**SUNDRY NOTICES AND REPORTS ON WELLS**  
*Do not use this form for proposals to drill or to re-enter an abandoned well. Use form 3160-3 (APD) for such proposals.*

8. Well Name and No.  
NEBU 443A

## PLUG AND ABANDONMENT PROCEDURE

CONDITIONS OF APPROVAL

## Proposed P&A

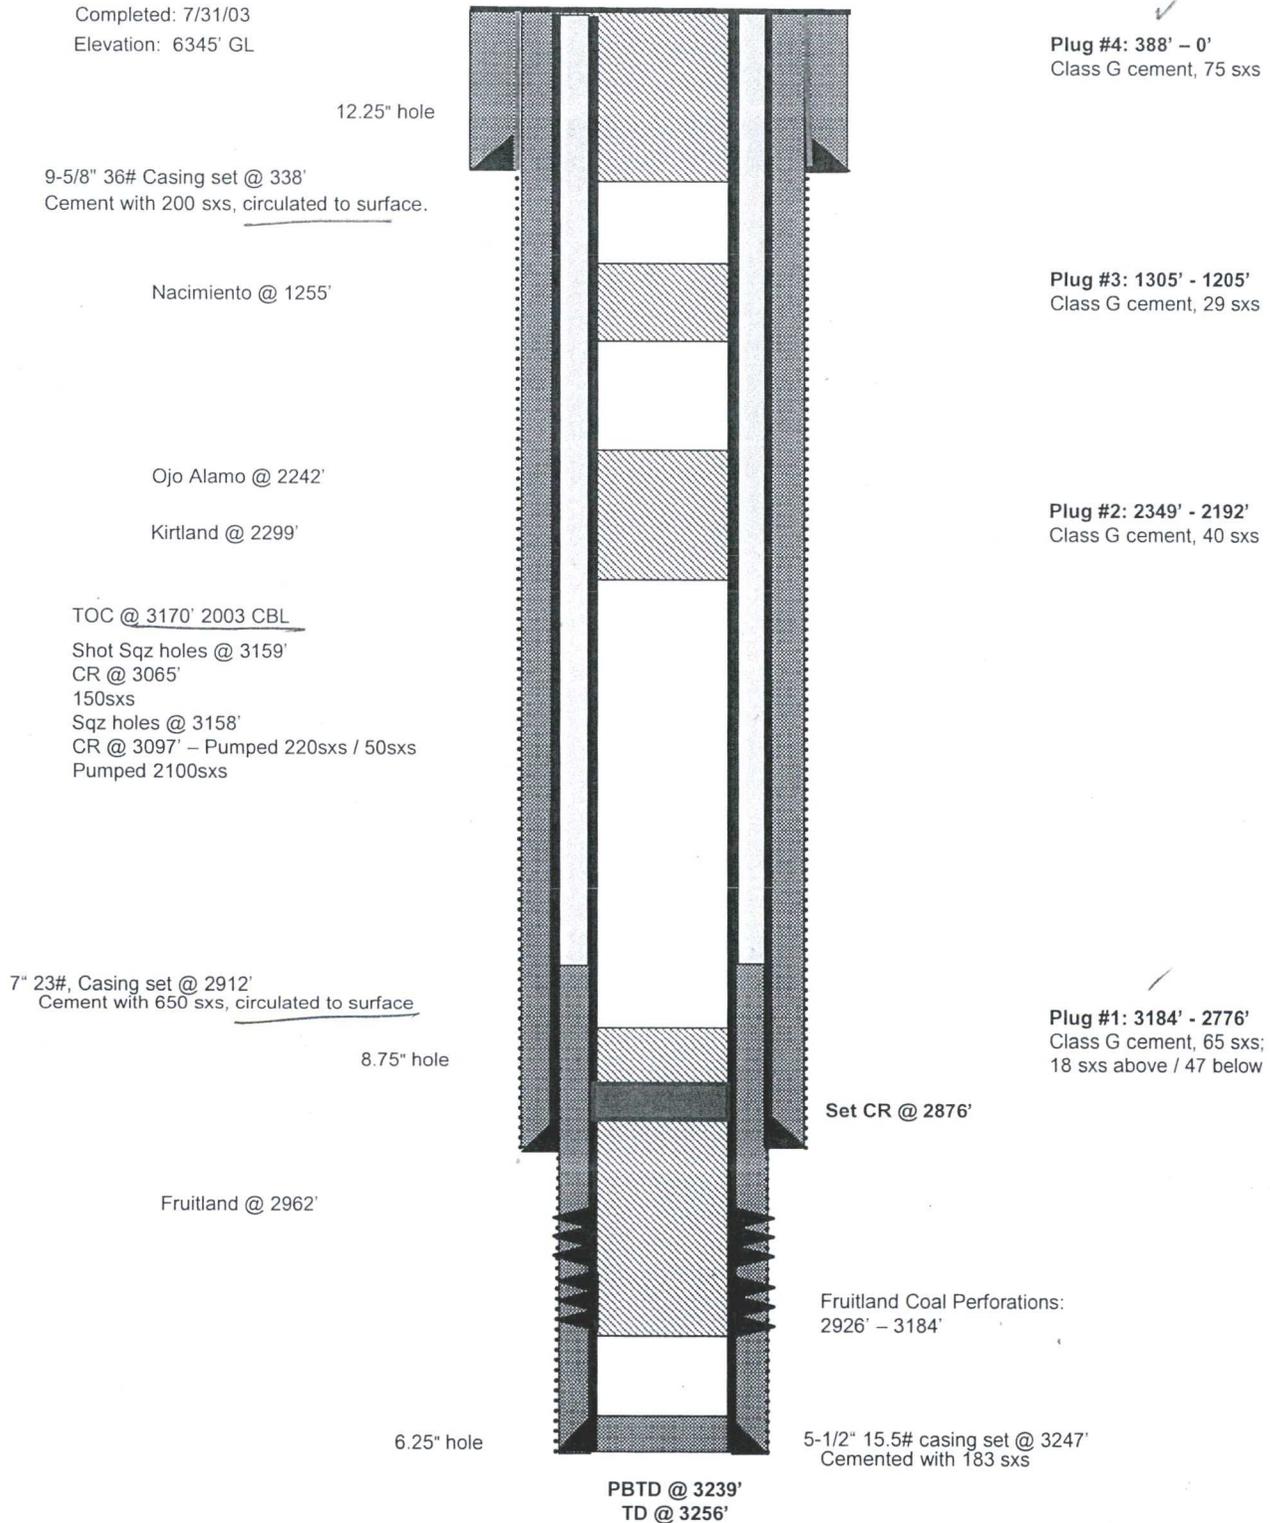
1. Plugging operations authorized are subject to the attached "General Requirements for Permanent Abandonment of Wells on Federal and Indian Lease."
2. Farmington Office is to be notified at least 24 hours before the plugging operations commence (505) 564-7750.
3. The following modifications to your plugging program are to be made:
  - a) Set Plug 3 (2294 – 2000) ft. to cover the Kirtland and Ojo Alamo tops. BLM picks top of Kirtland at 2244 ft. BLM picks top of Ojo Alamo at 2050 ft.
  - b) Set Plug 3 (890 – 790) ft. to cover the Nacmiento top. BLM picks top of Nacimiento at 840 ft.

Operator must provide CBL (2003) to verify cement top. Submit the electronic copy of the log for verification to the following addresses: [jwsavage@blm.gov](mailto:jwsavage@blm.gov) [Brandon.Powell@state.nm.us](mailto:Brandon.Powell@state.nm.us)
